ADDENDUM

RFB NO. 317012 - ADDENDUM NO. 1

DAY RESOURCE CENTER REMODELING

1 FENCE SECTION
1" = 1'-0"

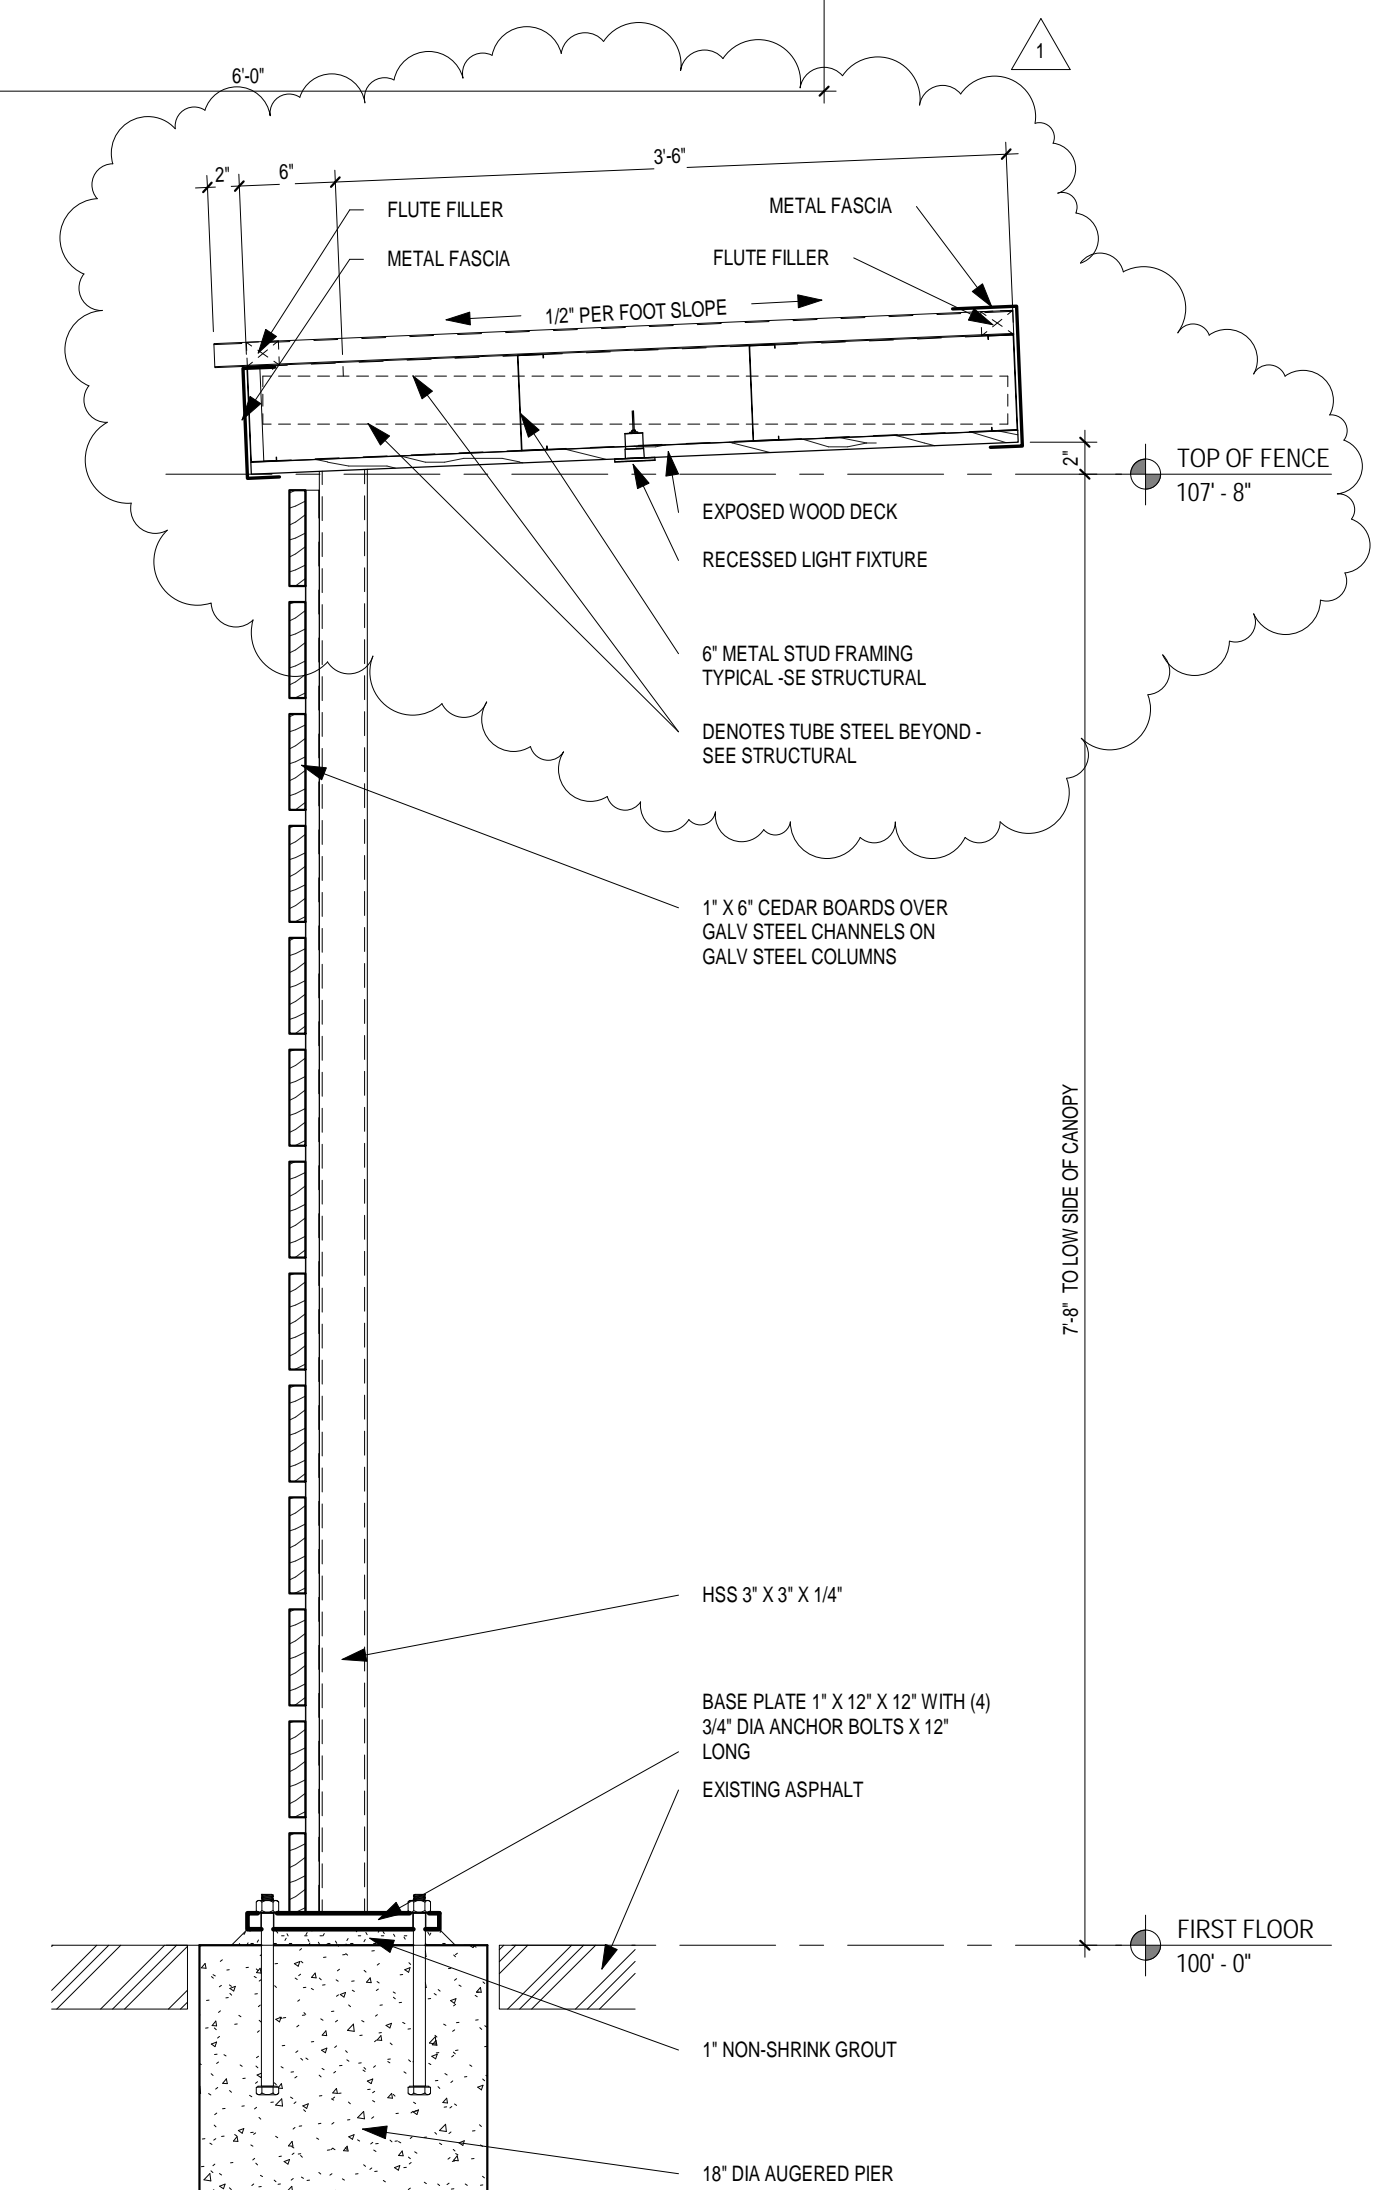
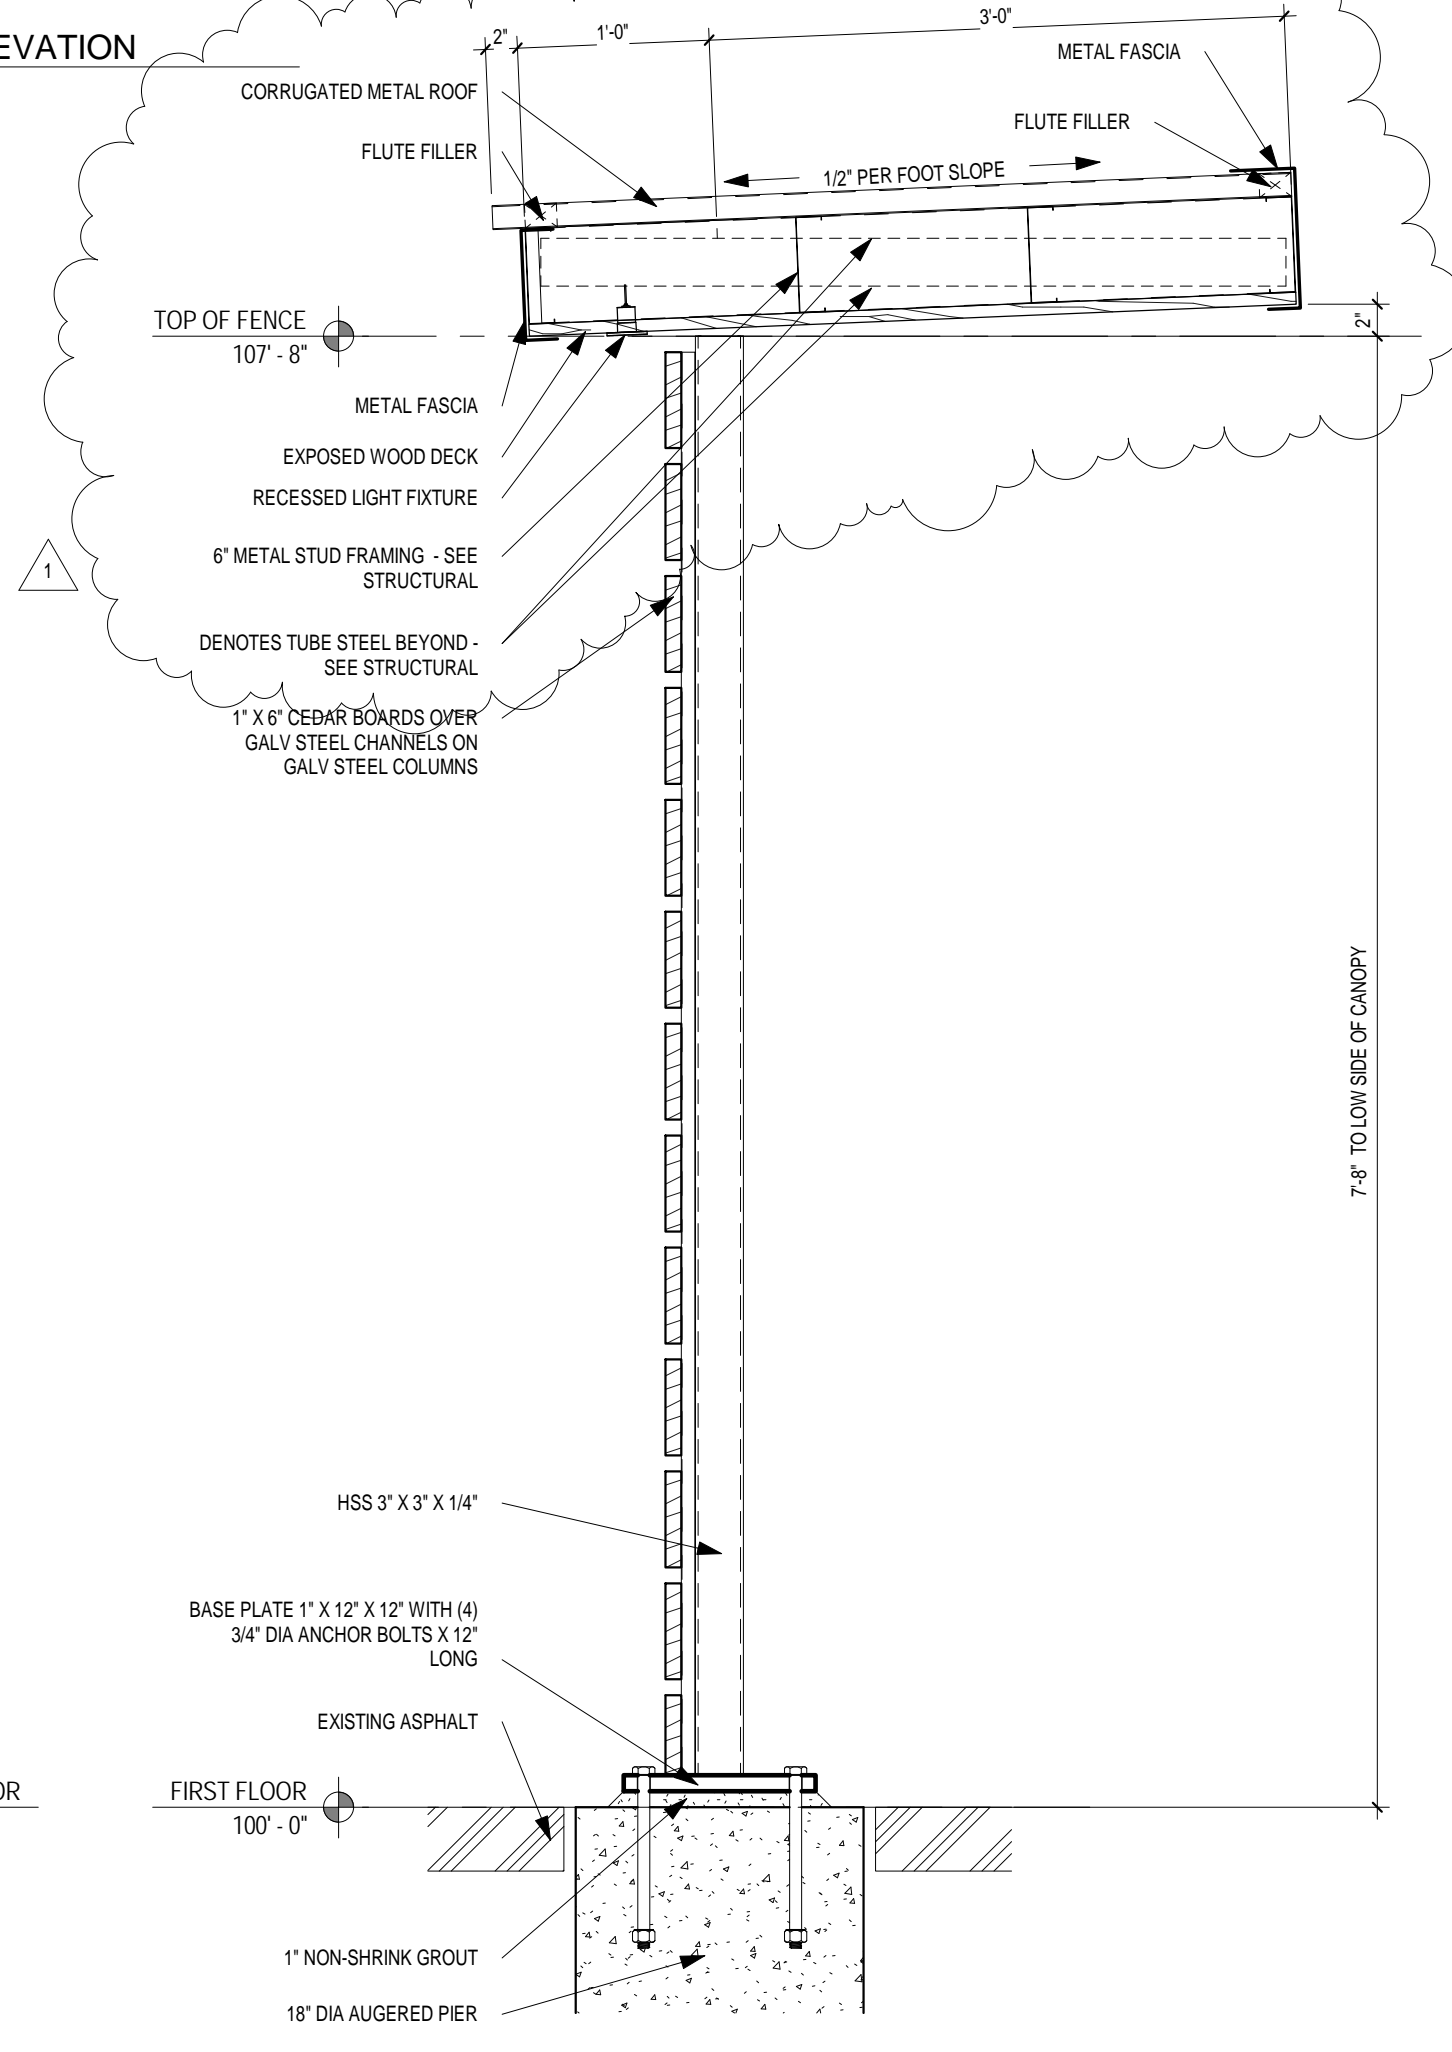
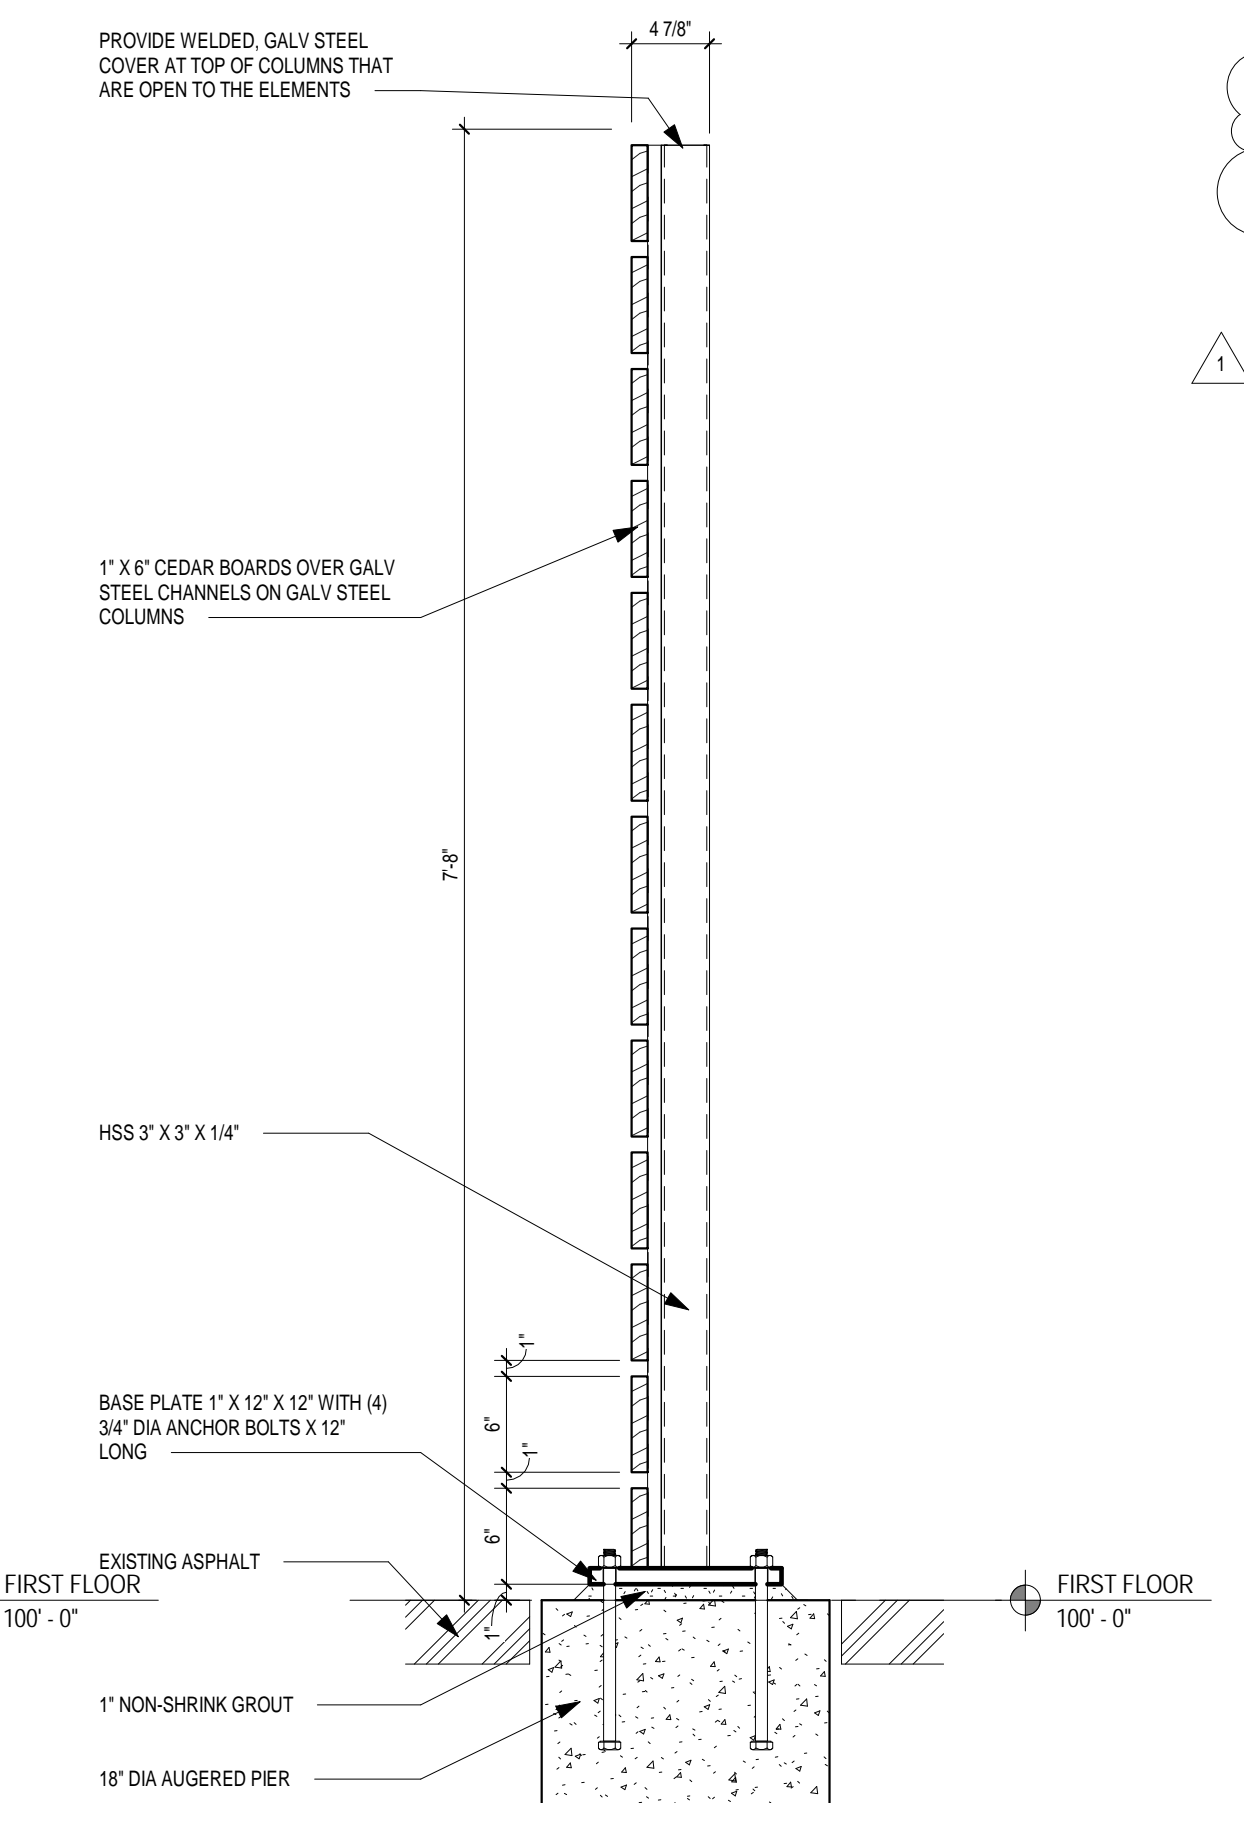
- b. Second Floor Resource Center 205: “Extend soffit at exposed structure plan north approximately 2’-0”, V.I.F. to conceal ductwork.”
6. A600
 - a. Refer to attached revised A600 for revised covered fence detail and additional concrete walk detail (Alternate Bid A).
